ADDENDUM NO. 3

ADDENDUM DATE: 05/14/2025
ADDENDUM NO.: 3
IFB TITLE: Sespe Creek Overflow Railroad Bridge Repair
IFB NO.: SPBL-2025-01

SESPE CREEK OVERFLOW
RAILROAD BRIDGE REPAIR

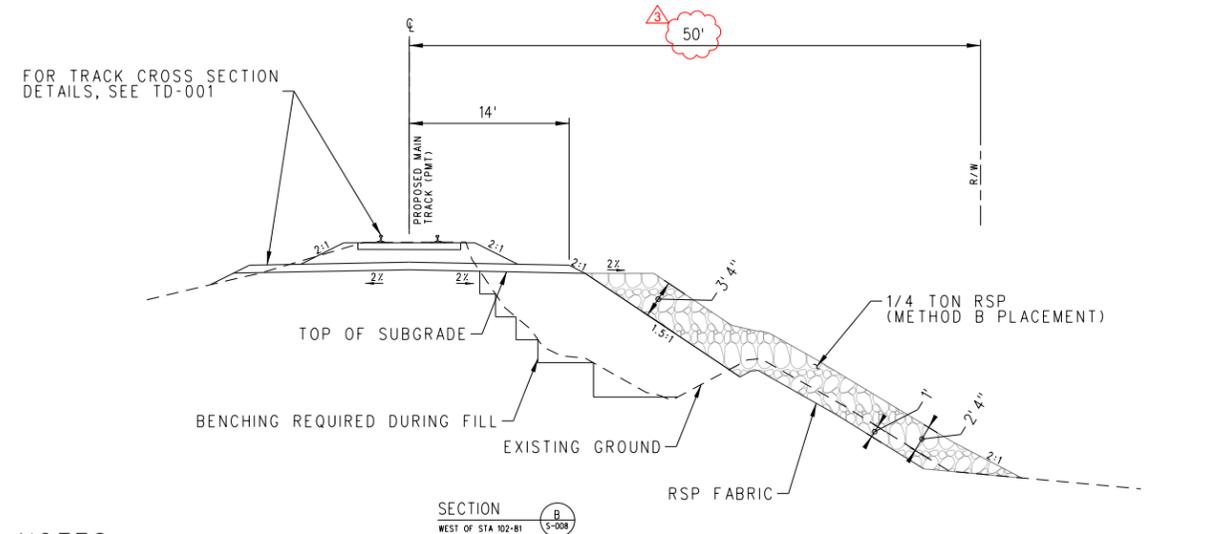
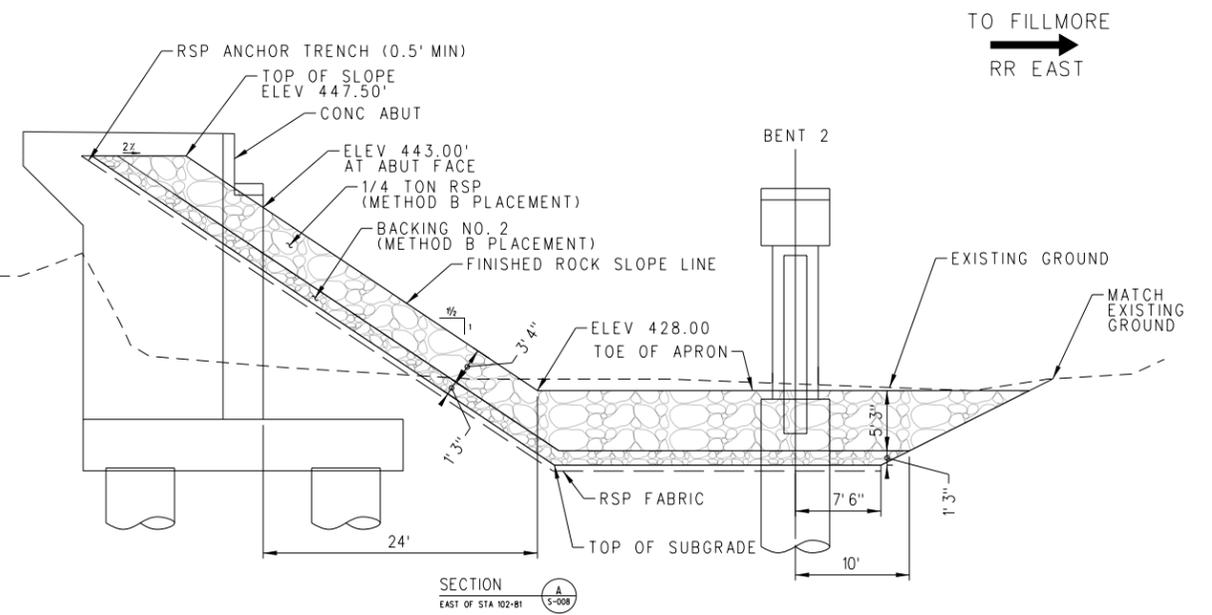
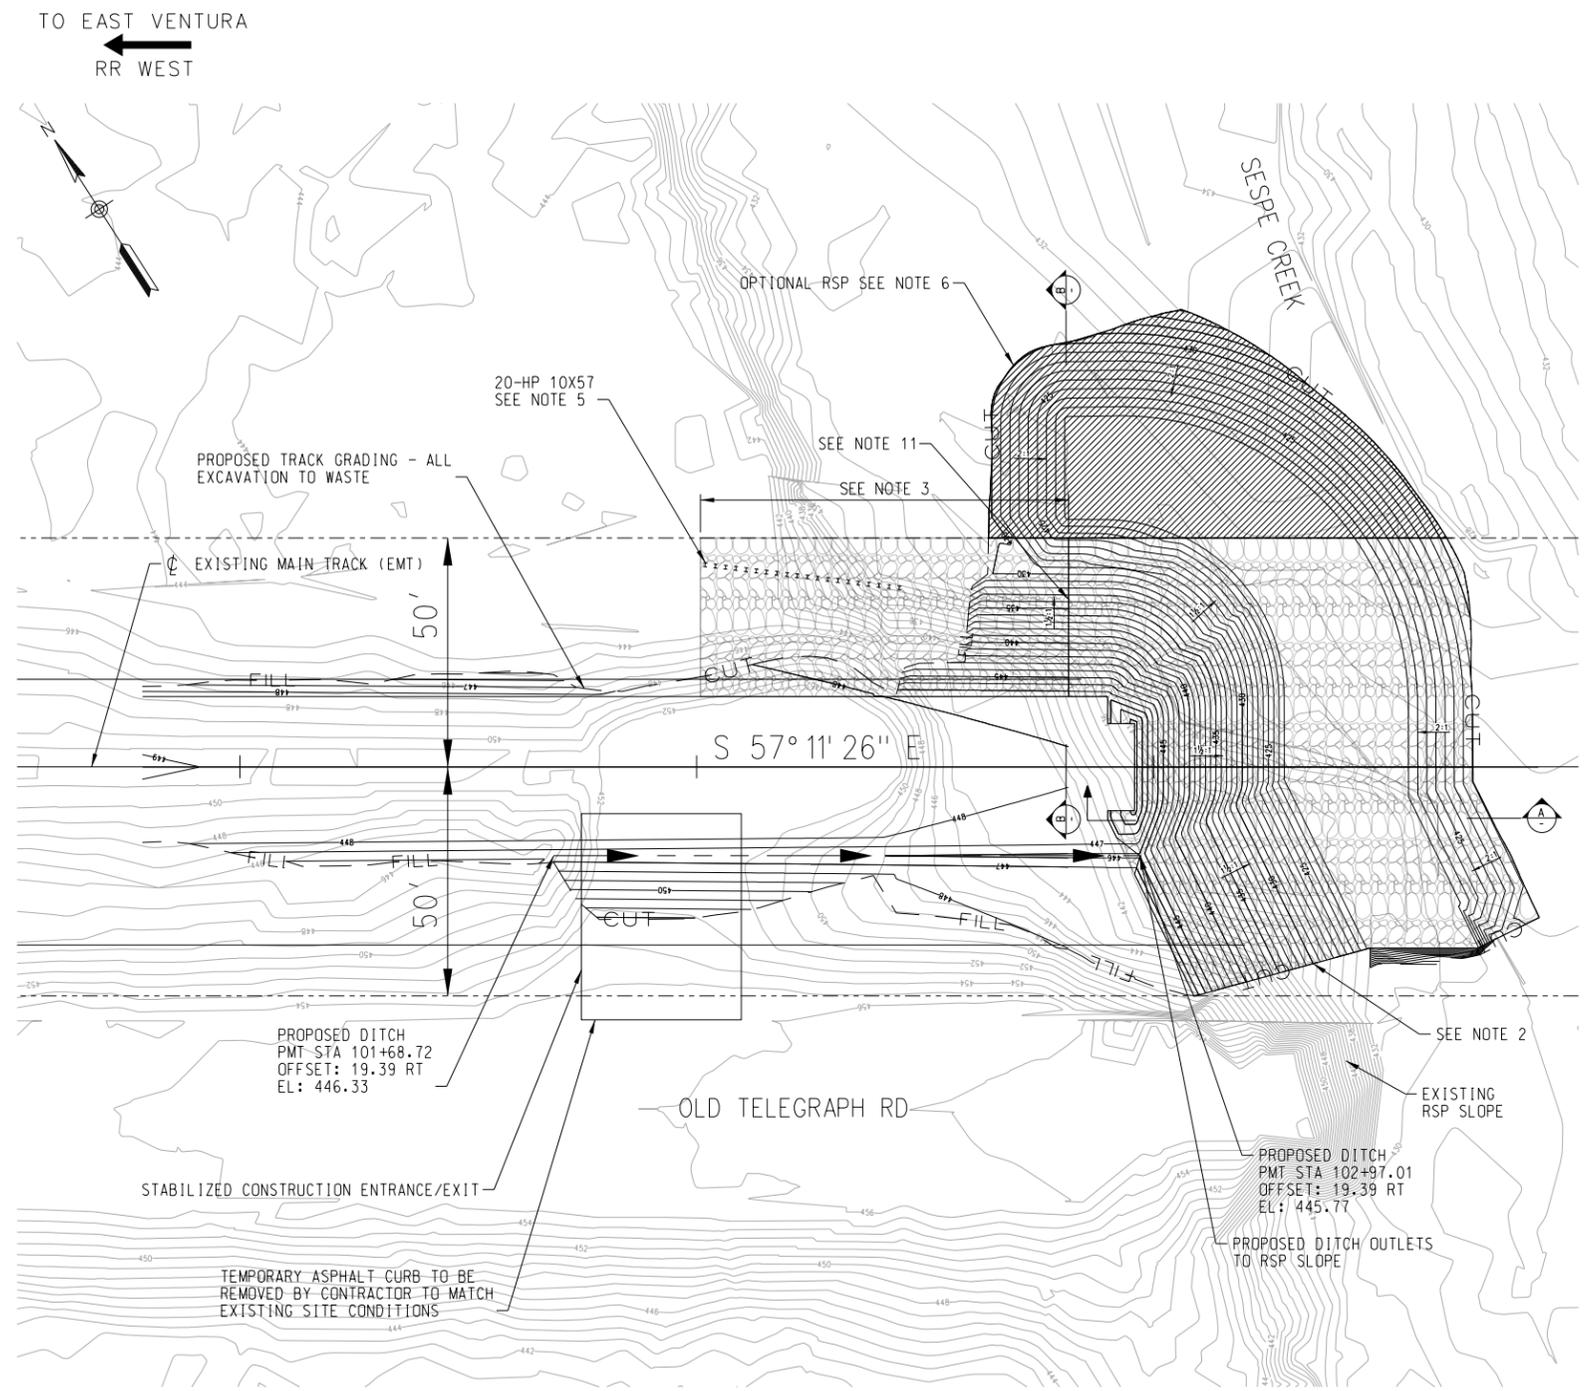
- i. Added item 1.02.F.
2. The Project Engineering Drawings has been revised for Sheet SC-002.
 - a. SC-002 was revised to indicate the distance between the CL of track to the limits of the railroad ROW line is 50'.
